D/DRC Case

1218 Daly Street

Melrose Heights/Oak Lawn Architectural Conservation District

NATURE OF REQUEST: Request Certificate of Design Approval for exterior change

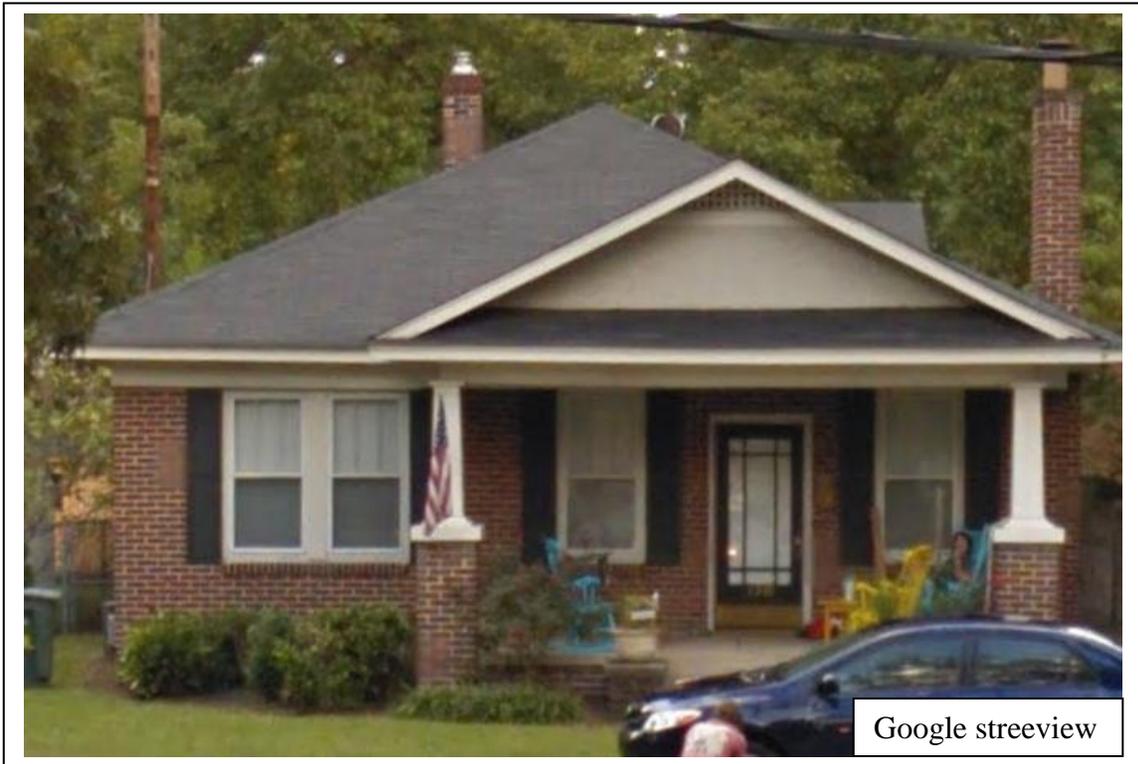
This guideline indicates that the door should have been repaired rather than replaced. Staff was not able to see the door prior to its replacement but its protection from the elements by the front porch suggests that rot should have been minimal. The door that was recently installed appears to have been a pre-hung, meaning that it required the removal of original trim in the opening. Finally, the new door appears to be a few inches shorter than the original, which has resulted in the addition of a sort of lintel above the door that is not reflective of the original trim design on the house.

The replacement of the door and trim does not meet this guideline.

Had the door been deteriorated then a door that “closely” matches the original is necessary to meet this guideline. The applicant has indicated that the door is “as similar to the original as possible,” and while the muntin design in the glass does attempt to repeat the pattern found on the original door, it fails to replicate the exterior muntins found on the original glass and instead has a faux muntin sandwiched between the glass. This creates what appears to be a large span of uninterrupted glass, with the faux muntins largely invisible in the reflective glare on the glass. The faux muntins also are much narrower than what existed on the original door; they do not have the width or dimensions of the original. The bottom rail of the original door was also taller than that of the replacement door.

Staff finds that the proposal does not meet Section 7 of the guidelines and recommends the request for the new door be denied.

New door, staff photo

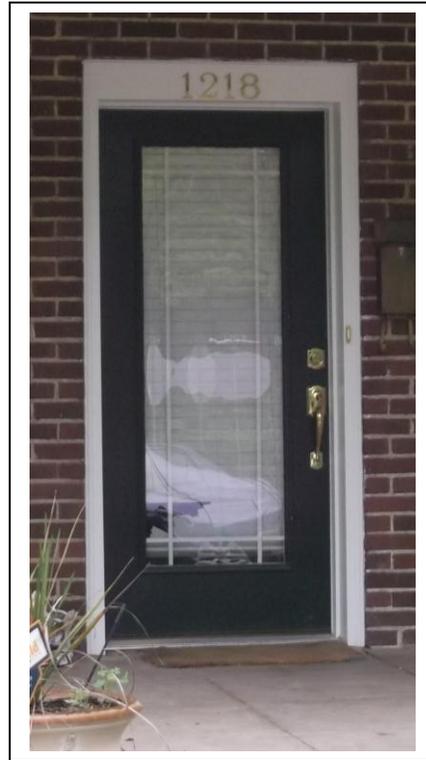
Staff finds that the door installed does not meet this guideline.

Staff has found a few manufacturers who supply this door type in a contemporary design that is largely compatible with the original door in that they have the exterior muntins that better replicate the original door. Home Depot and door companies carry these doors.
